A d d e n d u m

Iowa Department of Transportation
Office of Contracts

Date of Letting: May 21, 2013
Date of Addendum: May 16, 2013

B.O.	Proposal ID	Proposal Work Type	County	Project Number	Addendum
108	33-0037-029	PCC OVERLAY - UNBONDED	FAYETTE	NHSX-003-7(29)--3H-33 MP-150-2(704)59--76-33	21MAY108.A03

TABULATION OF PAVEMENT

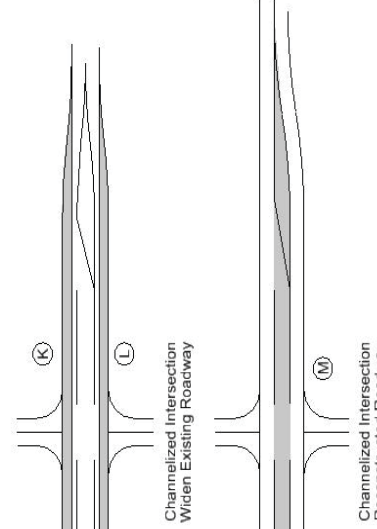
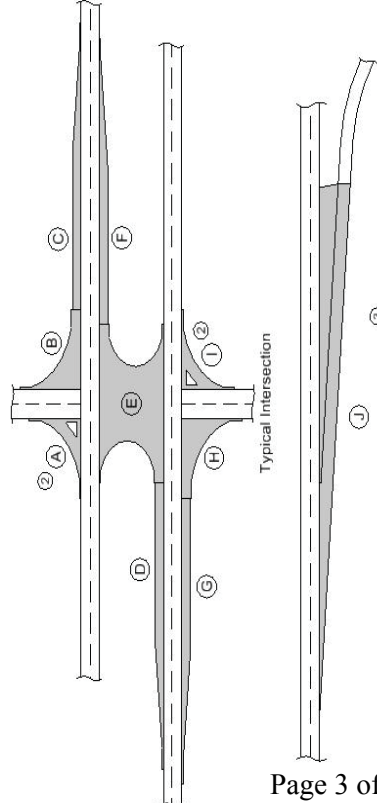
Make the following change to the Plan Sheet C.9 on Project No. NHSX-003-7(029)--3H-33:

Replace Tab. 100-24 TABULATION OF PAVEMENT with the attached Tab. 100-24 TABULATION OF PAVEMENT.

ESTIMATED QUANTITIES & NOTES
 STA. 1097+54.50
 MAY, 2013
 FAYETTE COUNTY
 IOWA DEPARTMENT OF TRANSPORTATION - HIGHWAY DIVISION
 DESIGN SHEET NO. 1 OF 2 FILE NO. 30854 DESIGN NO. 413

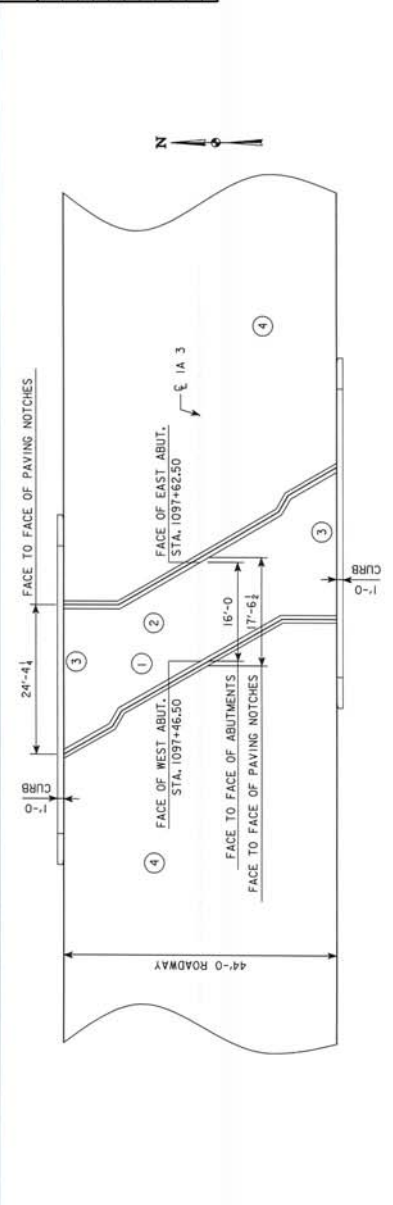
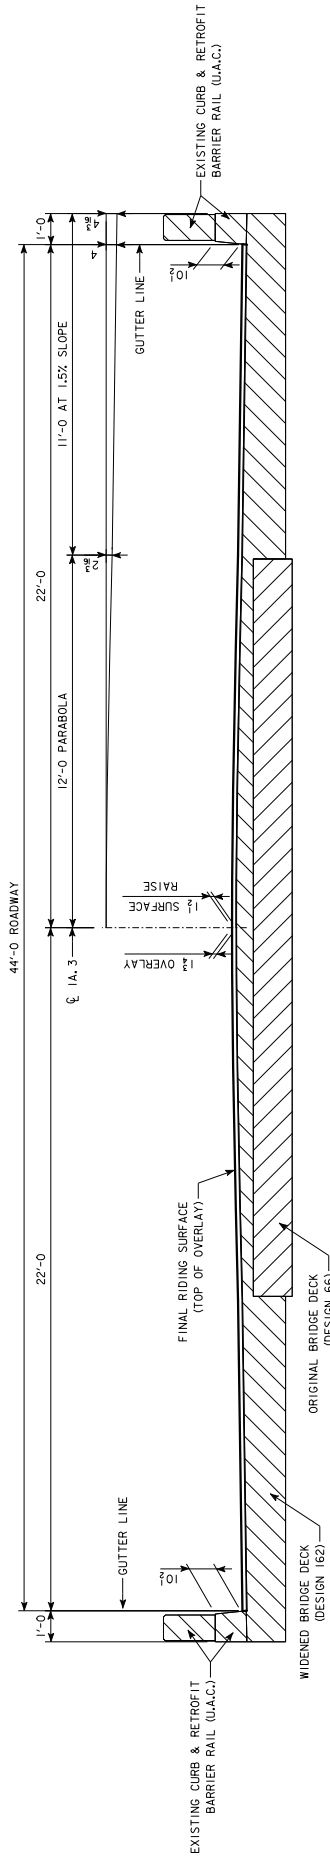
Add the attached Plan Sheet V.7 and Plan Sheet V.8.

ITEM NO. 3
 DESCRIPTION
 INCLUDES COST OF FURNISHING AND PLACING CONCRETE SEALER ON DECK, CURBS AND EXISTING RETROFIT RAIL. SEE DETAIL ON SHEET V.08

DESIGN FOR REPAIRS TO A 30° SKEW (R.A.)
16'-0" x 44' CONCRETE SLAB BRIDGE
 16'-0" SPAN
DECK REPAIR DETAILS
 STA. 1097+54.50
FAYETTE COUNTY
 IOWA DEPARTMENT OF TRANSPORTATION - HIGHWAY DIVISION
 DESIGN SHEET NO. 2 OF 2 FILE NO. 30854
 MAY, 2013

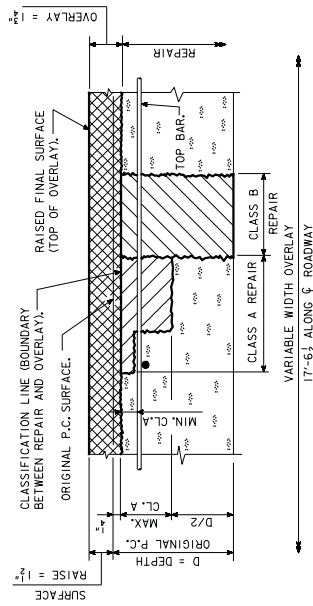
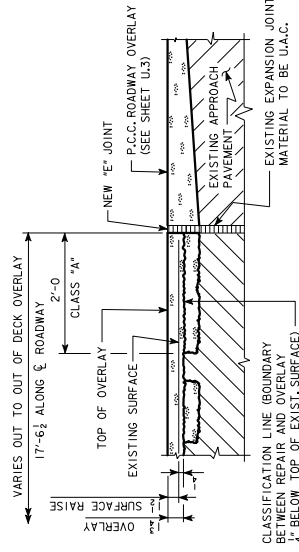
Deck overlay shall be used on the bridge at station 1097+54.5 and includes the cost of furnishing and placing concrete sealer on the deck, curb, and existing barrier rail. See Sheets V.7 and V.8 for additional information. Stationing is based on as-built bridge plans. Contractor to verify stationing.
